**UPDATED FINAL SAFETY ANALYSIS REPORT
SUPPLEMENT**

OCONEE NUCLEAR STATION, UNITS 1, 2, AND 3

OCONEE NUCLEAR STATION
UFSAR SUPPLEMENT FOR LICENSE RENEWAL

Oconee Nuclear Station
UFSAR Supplement For License Renewal
Proposed Changes

Appendix 16.6-2
Figure 1
Units 1, 2, and 3

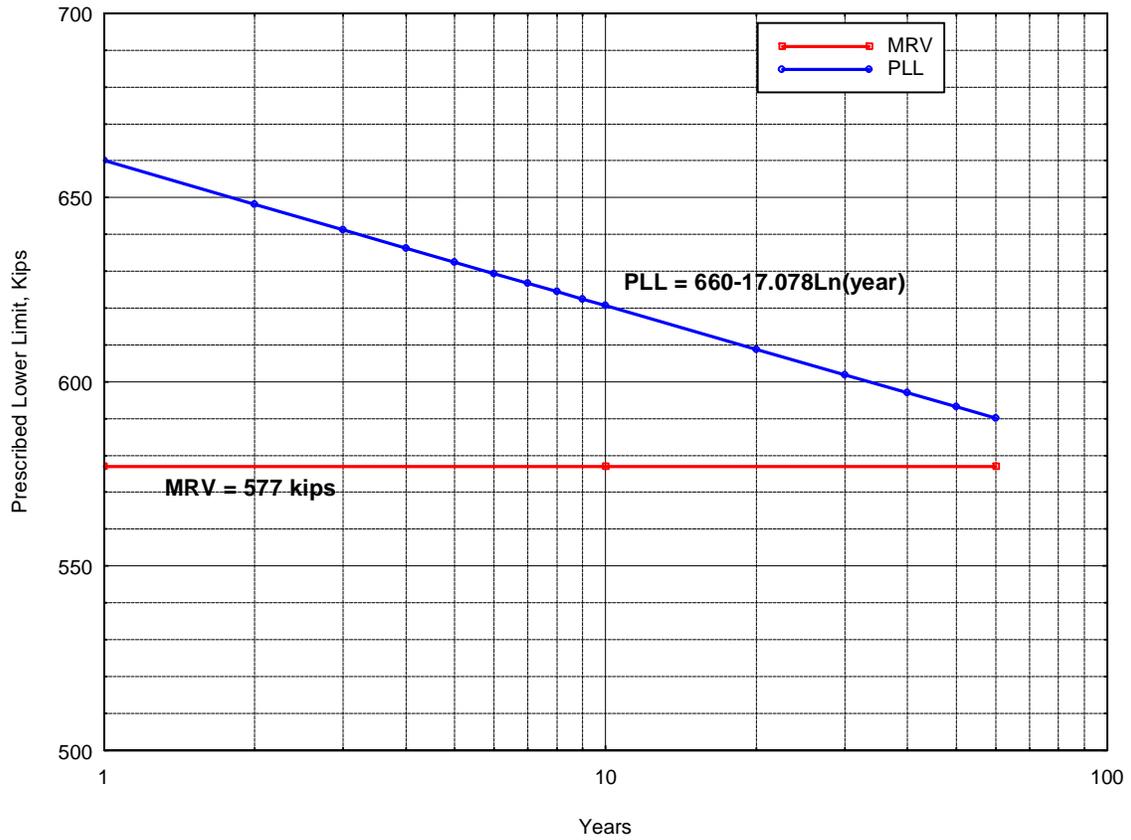
Revise Figures 1, 2, and 3 of SLC 16.6.2 as follows:

Estimated 60 Year Prescribed Lower Limit
Dome Tendons

have been developed using the guidance contained in Regulatory Guide 1.35. Each prescribed lower limit line has been extended to 60 years of plant operation and remains above the minimum required values for all three tendon groups.

Appendix 16.6-2
Figure 2
Units 1, 2, and 3

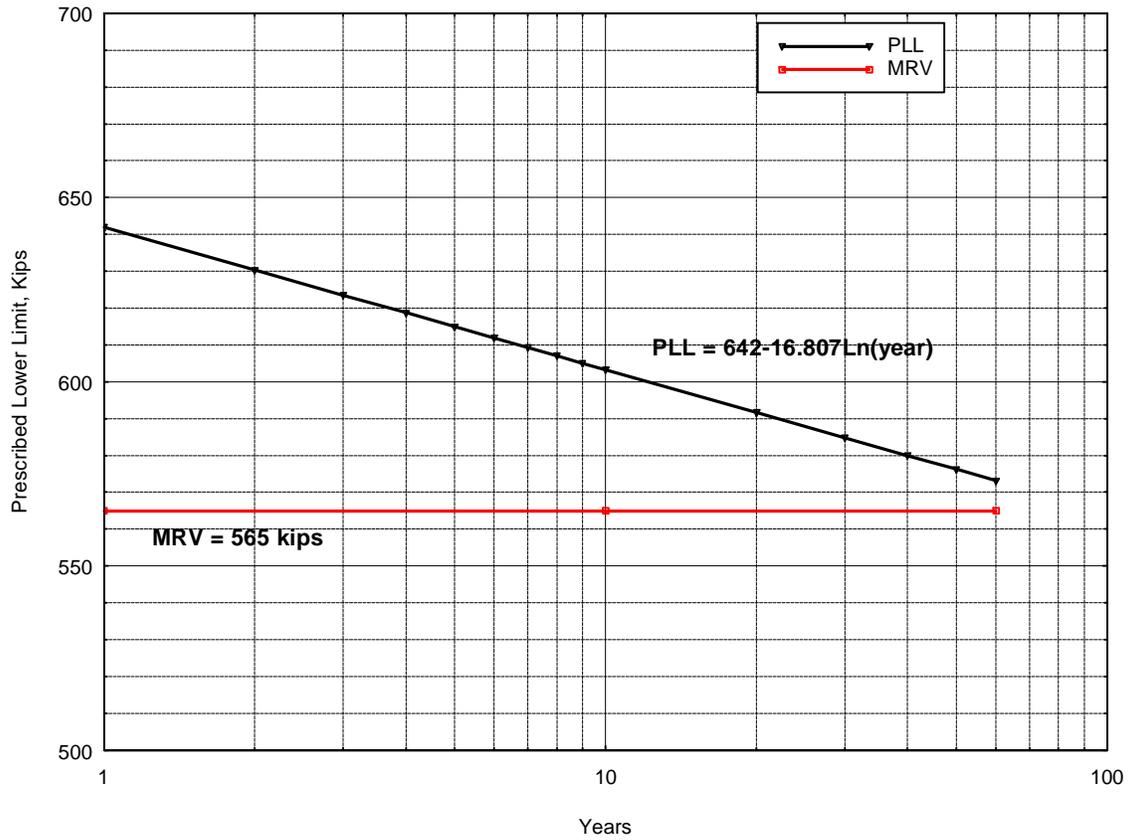
Estimated 60 Year Prescribed Lower Limit
Hoop Tendons
